CONSTRUCTION SUMMARY

25 - 1 - The Rideau 4 (42-4) Elev C

Extras at Time of Sale

Ground Floor
Elevation A

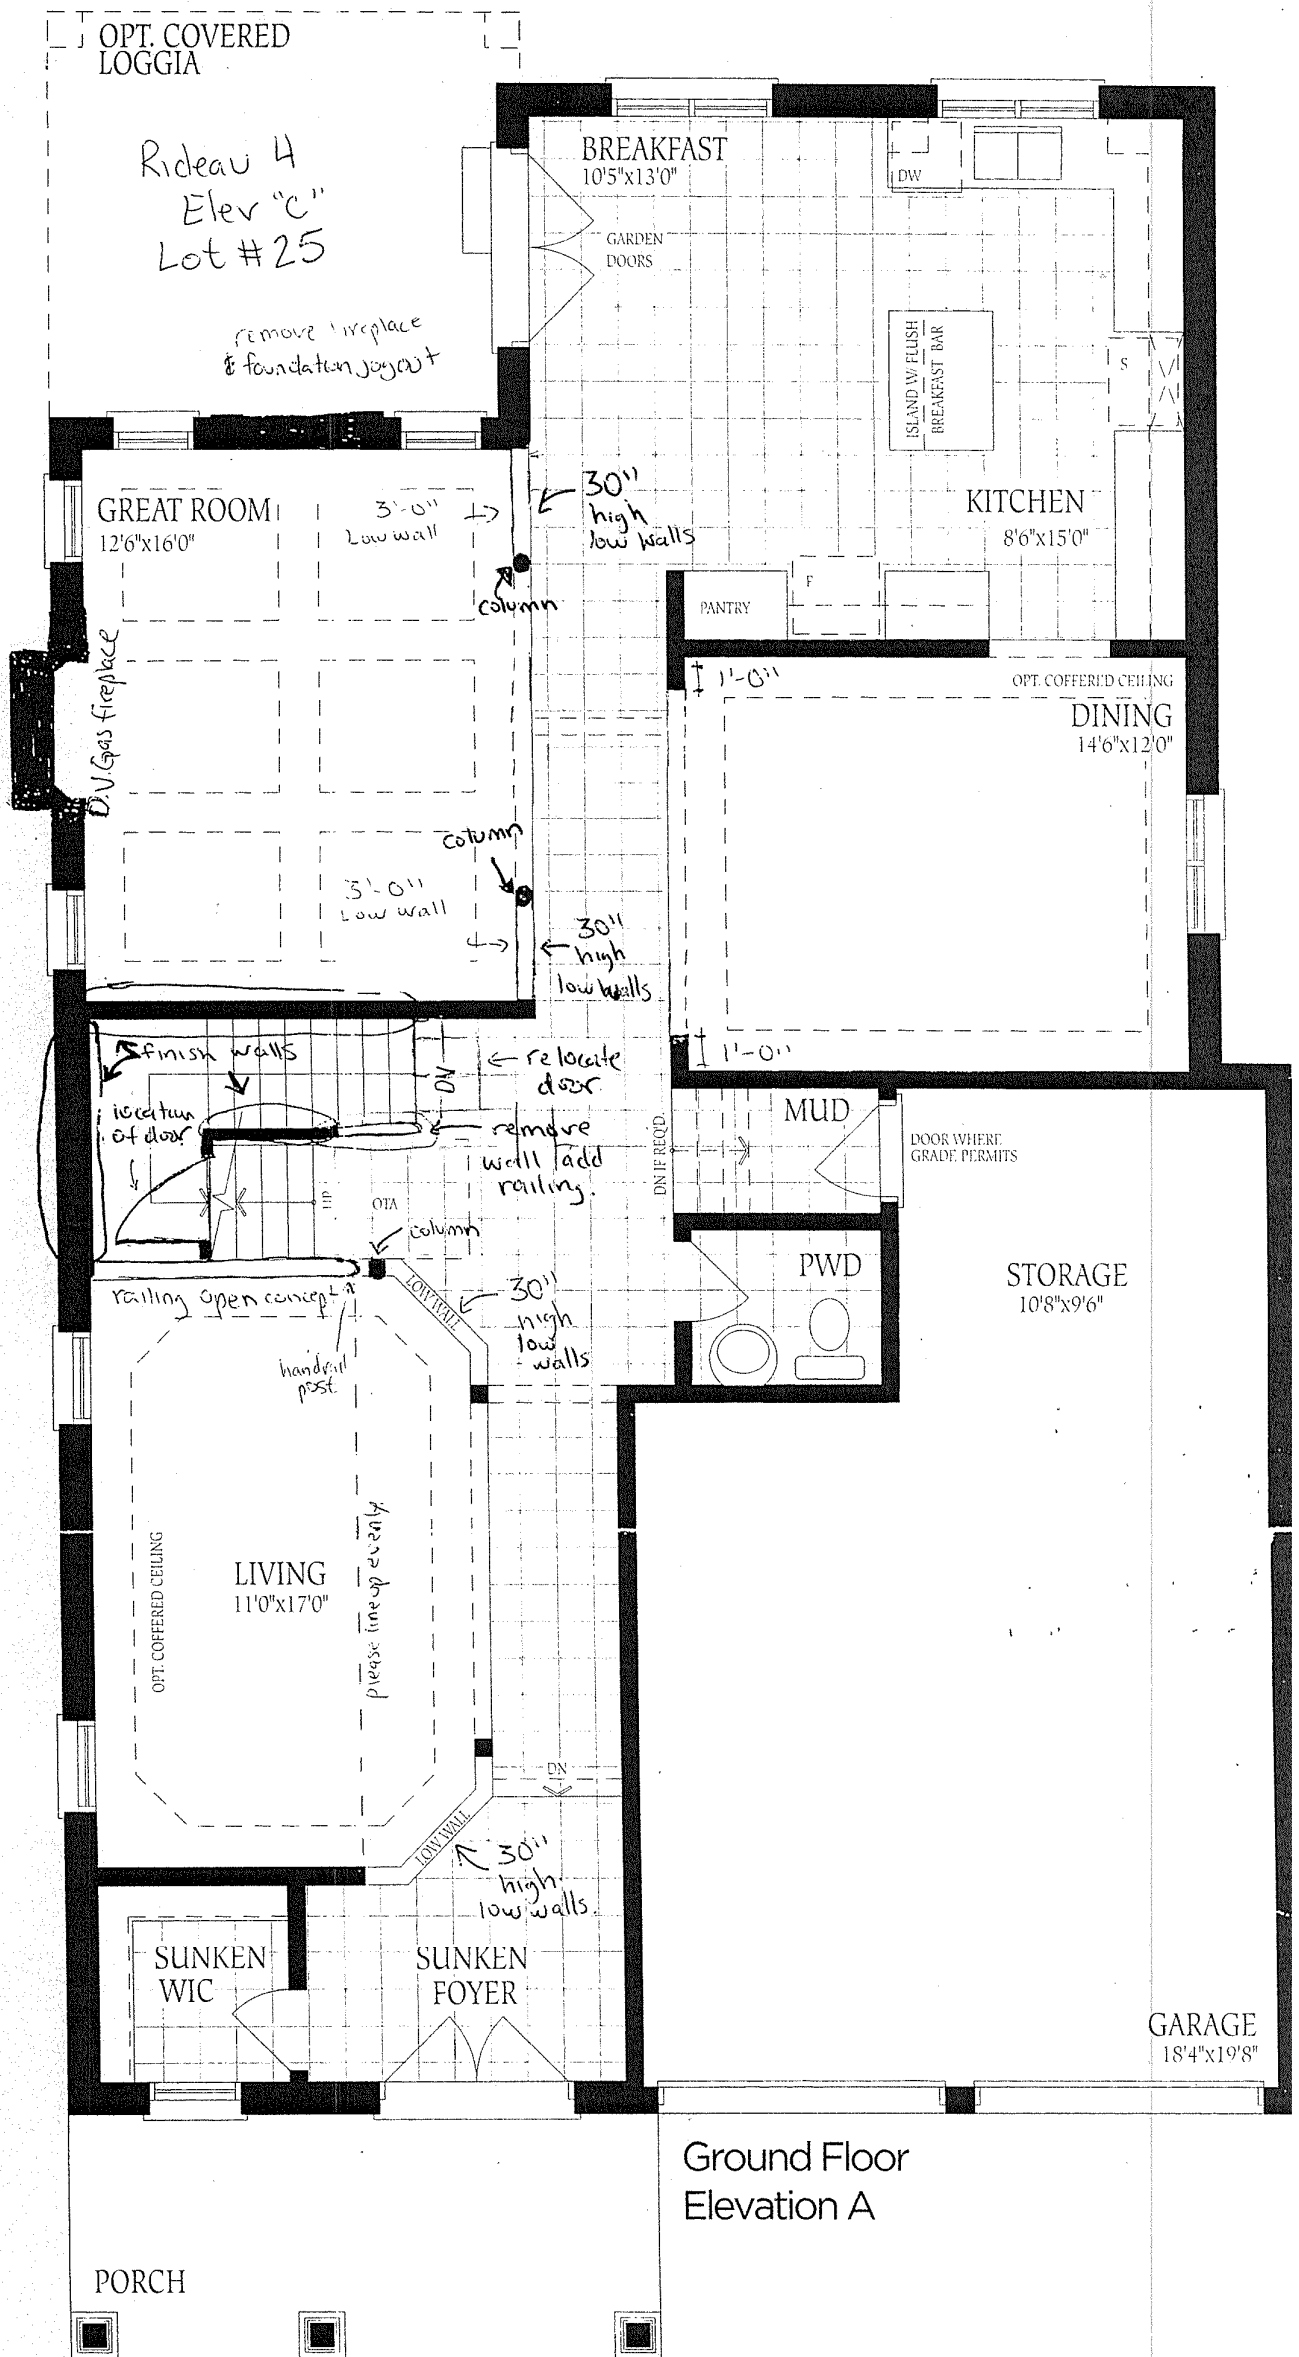
| Inv.3 | 1 - RELOCATE FIREPLACE IN GREAT ROOM TO BE CENTERED IN BETWEEN WINDOWS ON THE SIDE OF HOUSE. AS PER SKETCH FIREPLACE TO BE RECESSED ON EXTERIOR OF HOUSE AS THIS IS A PREMIUM PIE SHAPED LOT -AS PER JUSTIN |
| Inv.3 | 1 - INCREASE SIZE OF OPENING IN DINING ROOM BY FURTHER REDUCING THE WALLS TO BE 1' -0" ON EITHER SIDE AS PER SKETCH. |
| Inv.3 | 1 - REMOVE AND CLOSE OFF DOOR TO BATHROOM FROM MEDIA LOFT, AS PER SKETCH. |
| Inv.3 | 1 - CREATE 3'-0" LOW WALL WITH COLUMNS BETWEEN GREAT ROOM AND KITCHEN ON BOTH SIDES INSTEAD OF WALL IN CENTRE -LOW WALLS TO BE 30" HIGH - AS PER SKETCH |
| Inv.111 | 1 - CREATE AN OPEN STAIRCASE IN THE LIVING ROOM BY REMOVING WALL- AS PER SKETCH |
| Inv.111 | 1 - REMOVE DOOR LEADING INTO BASEMENT AND RELOCATE ON LOWER LANDING - AS PER SKETCH PURCHASER WOULD LIKE TO ENSURE DOOR IS AS PER SKETCH AND WILL BE THE SAME AS MODEL HOME #52 LEFT (SEDONA 4) |
| Inv.111 | 1 - ADD COLUMN TO LOW WALL IN LIVING ROOM - AS PER SKETCH |

| Inv.111 | 1 - REMOVE WALL LEADING TO BASMENT AND ADD STANDARD OAK RAILING AS PER SKETCH |
